INDESIT company

RA24EU

F040804

51420a0 Exploded views

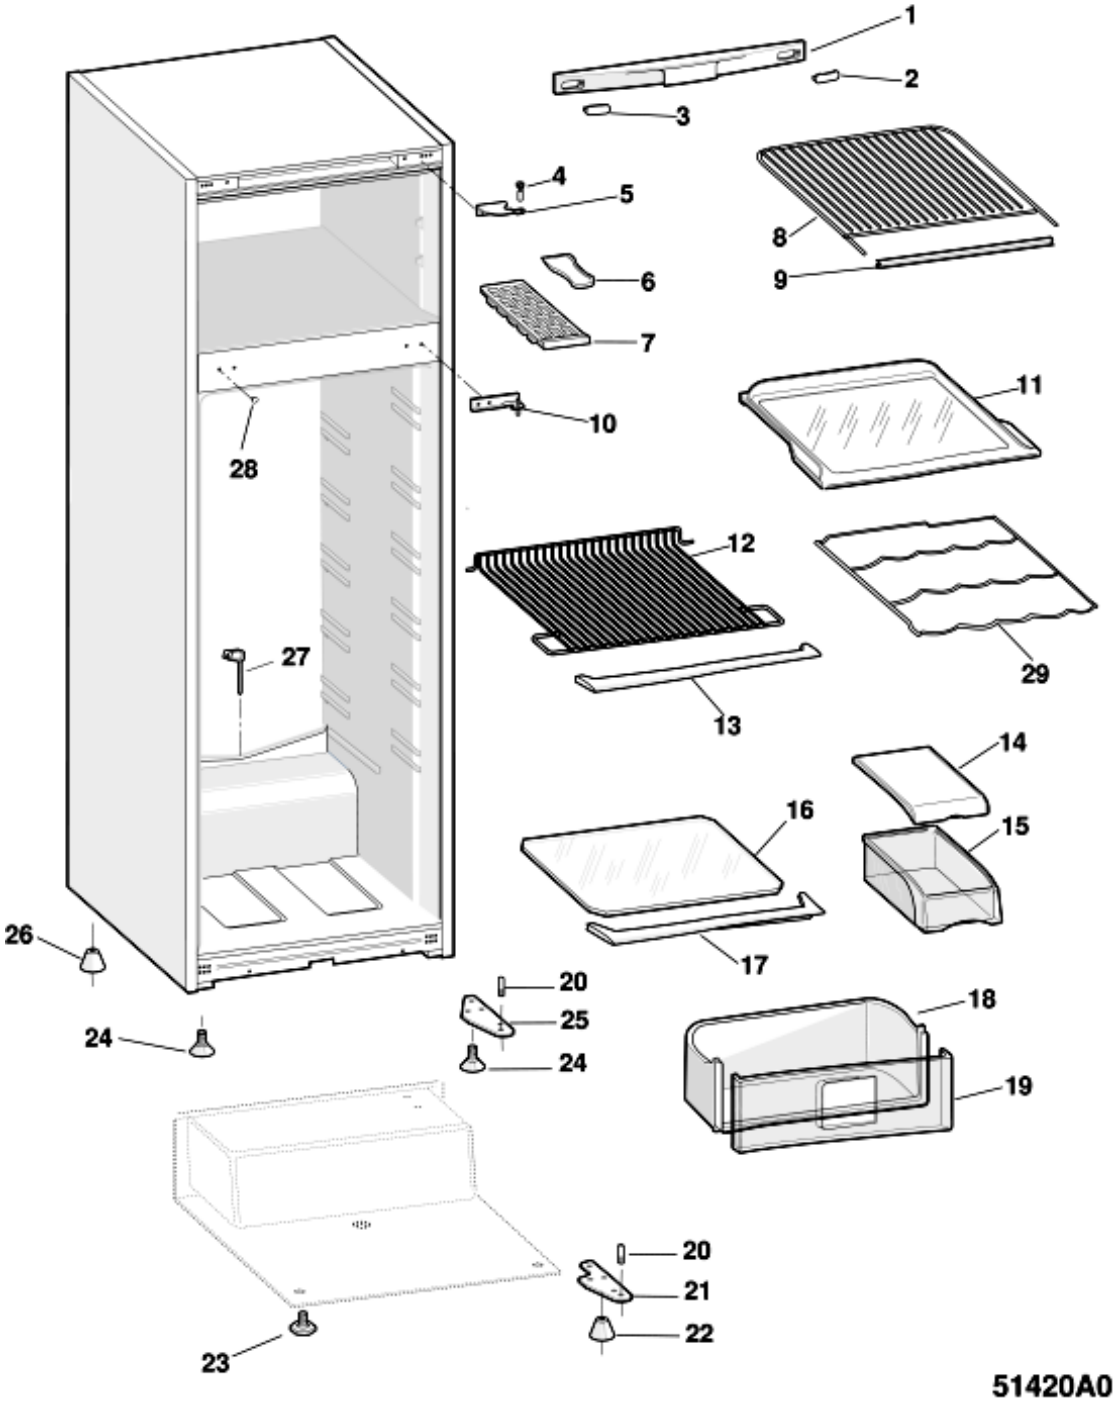
n3012c01: LOWER HINGE CHANGE

LOWER HINGE CHANGE

51421h0 Exploded views

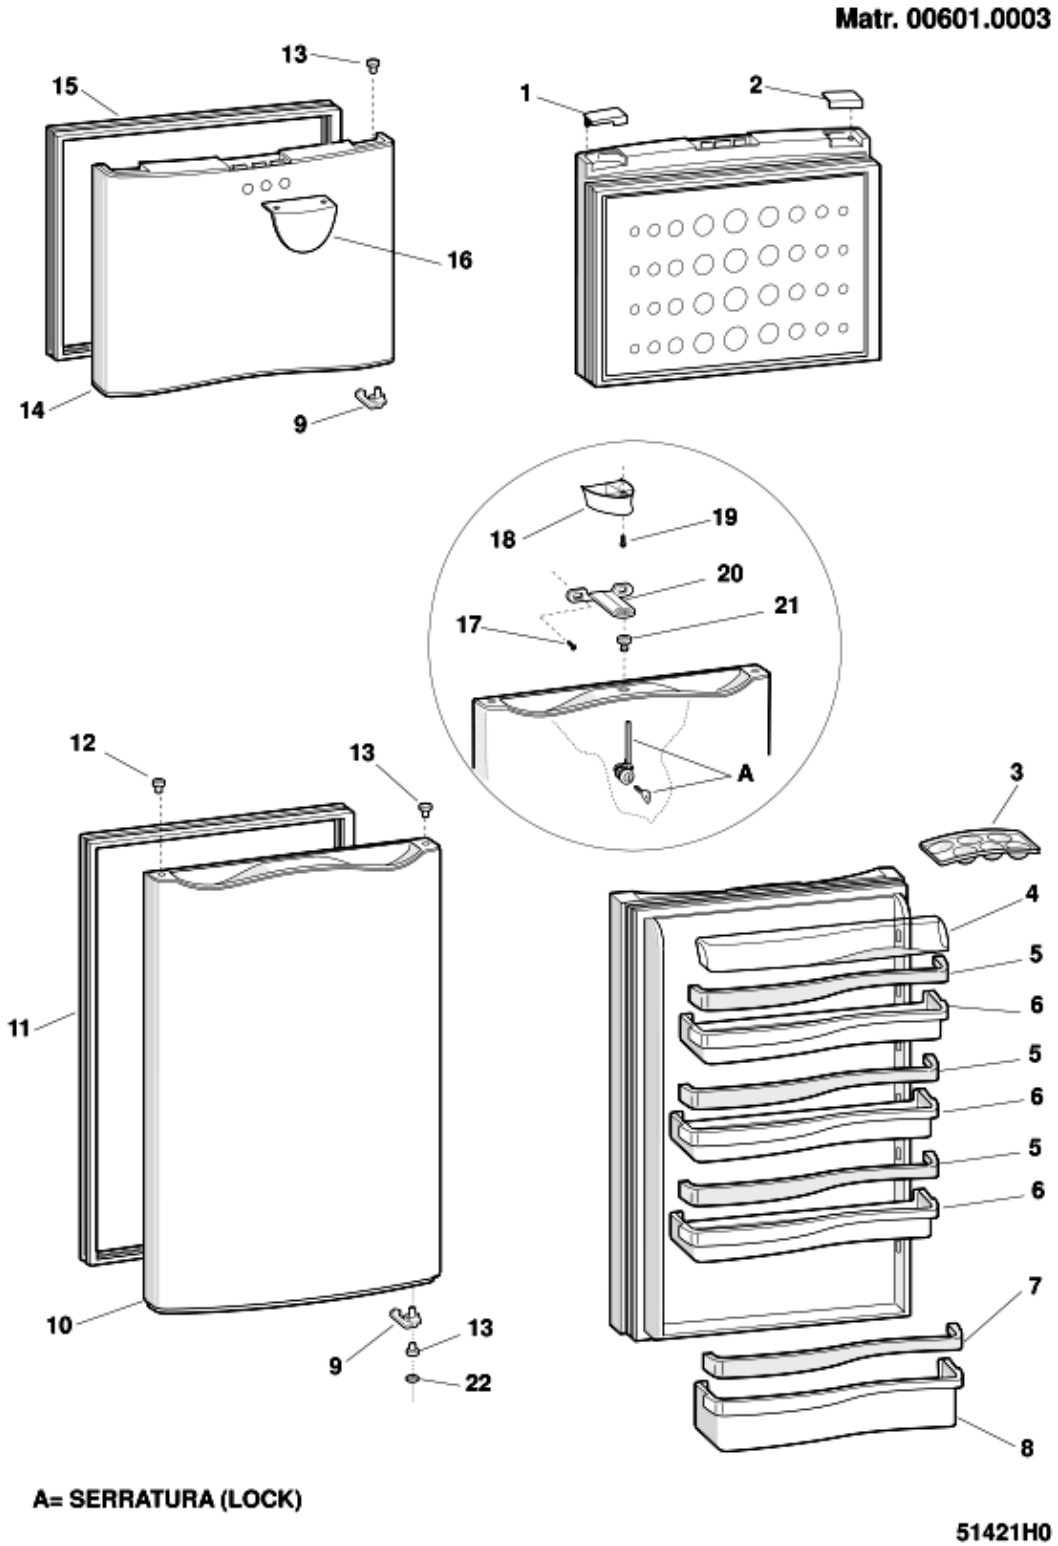
n1025110: Little lids for the door panel for the right opening version Indesit 2000 - 600 mm wide

From October 2001, little lids for door panel are available for the SAT code, to use on refrigerators and on combined-freezers (600mm wide), belonging to the series Indesit 2000, when the door opening is changed from right to left.
In fact, only on the product, which has the right hinges, the little lids of the piece of furniture are reversible; whereas those belonging to the door panel are specific for the right door opening.
The little lids for the version with left hinges are contained in specific coloured kit, which contain also the taps for closing the holes on a piece of furniture, which remain free on the opposite site of the central hinge.
It is important to remember that the holes to fix the central hinge are not present on the left site of the piece of furniture, when the door opening is converted. The holes are indicated only with a punching. The holes have been done after the work-ending with a 3mm bit

n3011e00: CHANGED EGG HOLDER FROM PW TO TRANSPARENT

CHANGED EGG HOLDER FROM PW TO TRANSPARENT

5142220 Exploded views

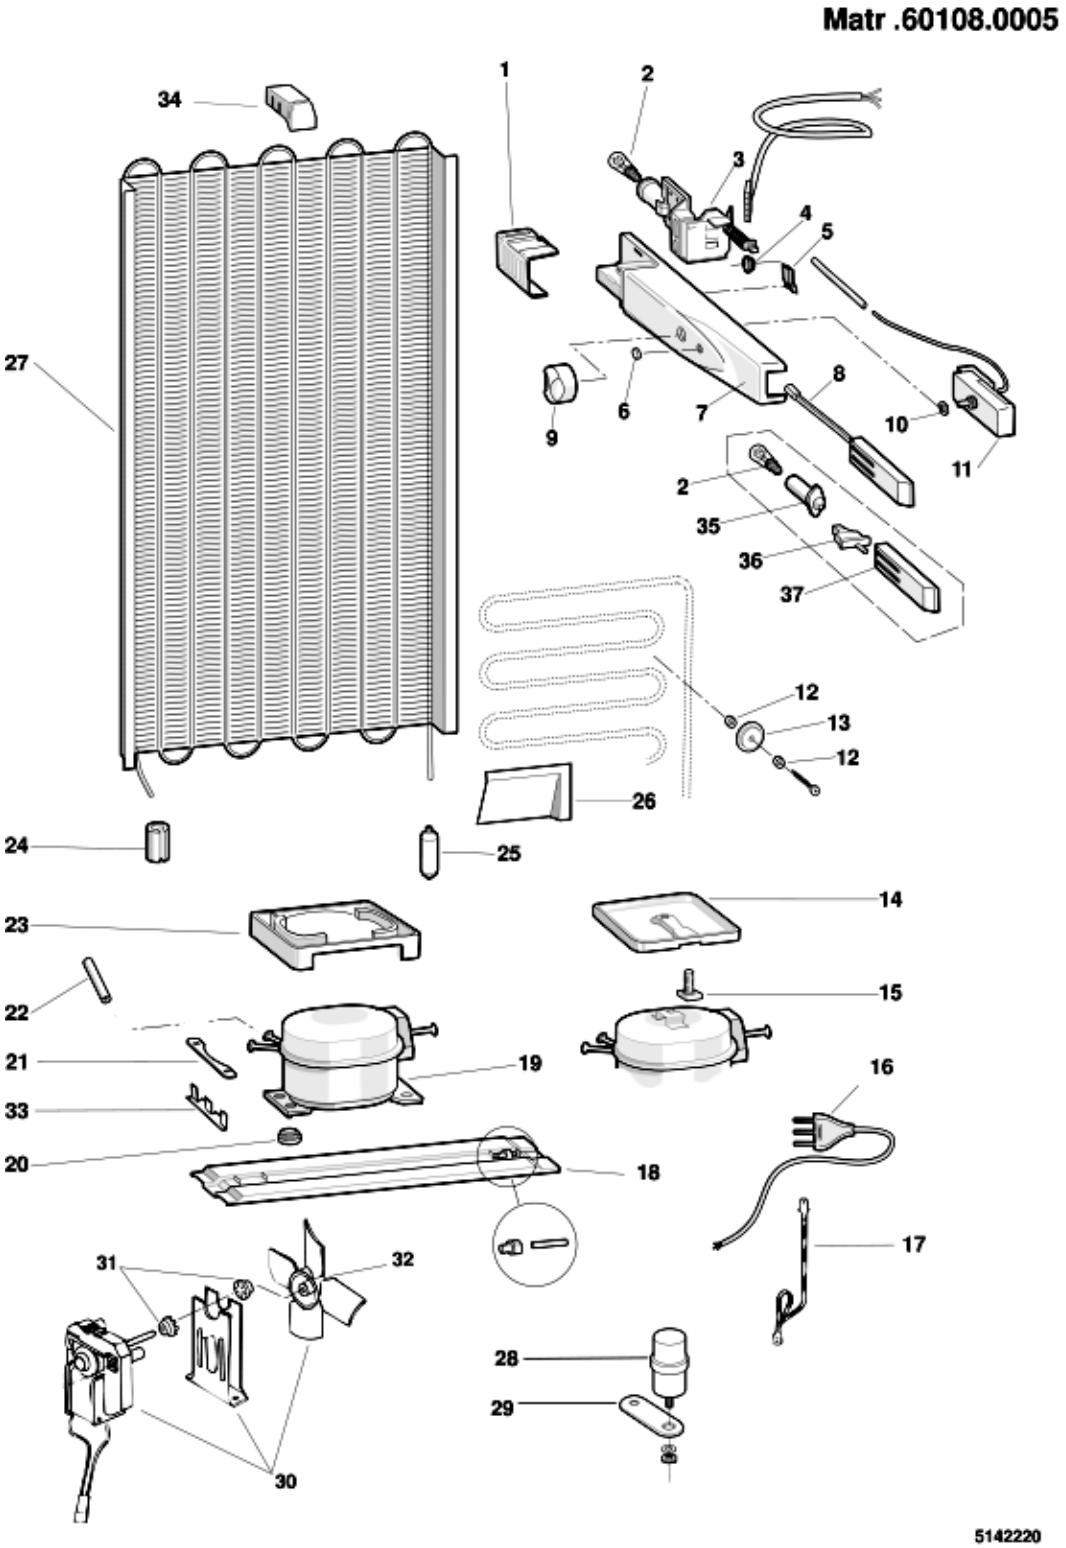
n1025065: Giugiaro-Vossloh thermostat box kit (low Ambient Temp. +16?C)

As of February-2001 (serial no. 10201.0001), the "thermostat box KIT for low ambient temperatures" is being handled with part number 076283 and is to be used on Indesit brand double-door refrigerators that have the Giugiaro thermostat box fitted on them (048503 - 066297).
The kit should be used exclusively to solve those problems obtained due to the poor performance of the freezer due to an ambient temperature below +16°C.
The kit is innovative, as it has a 6.6 Watt resistance fitted inside the thermostat box that should be activated by the toggle switch with a rubber protection situated underneath the thermostat knob. The switch is activated when the ambient temperature drops below +13°C (contacts closed. See the wiring diagram included in the kit).
This resistance heats up and enables the thermostat to be reactivated, thereby allowing the appliance to operate correctly.
On the thermostat box, the resistance is glued onto an aluminium plate (152x42) itself glued to the box.

When replacing the thermostat box, no components should be re-used, and this includes the wiring.
The wiring in the kit has terminals with fastons for connecting them to the compressor's terminal board; in the event of different solutions, then make the suitable adjustments as necessary.
Moreover, the thermostat box in the kit was obtained from the Giugiaro one (066229) with the Vossloh lamp holder and the Eltek switch. On this box, the position of the fixing hole was moved 15 mm up; therefore, on the models that are fitted with the Giugiaro thermostat box (048503), the hole on the cabinet should be remade before mounting the kit.
Moreover, on the models that use the hidden bulb thermostats, the position of the mark should be remade on the thermostat in the kit and, if necessary, the sheath protecting the bulb should be removed.
